GBL Package Stopper Dimension Comparison Report

Prepared by Owen Wang
Approved by Quayer Chen
Issued date at 11th Sep., 2014
Reversion for A

Comparison report (GBL package stopper dimension change)

Stopper dimension change comparison :

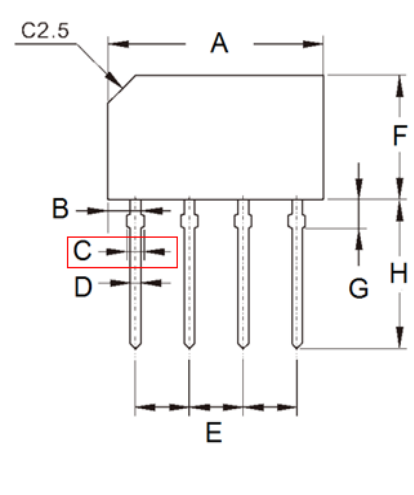
Before				After				Drawing
Item	C			Item	C			
Spec. (mm)	1.3 ~ 1.7			Spec. (mm)	1.3 ~ 2.0			
Mean (mm)	1.54			Mean (mm)	1.78			
Max. (mm)	1.550			Max. (mm)	1.810			
Average (mm)	1.536			Average (mm)	1.788			
Min. (mm)	1.510			Min. (mm)	1.780
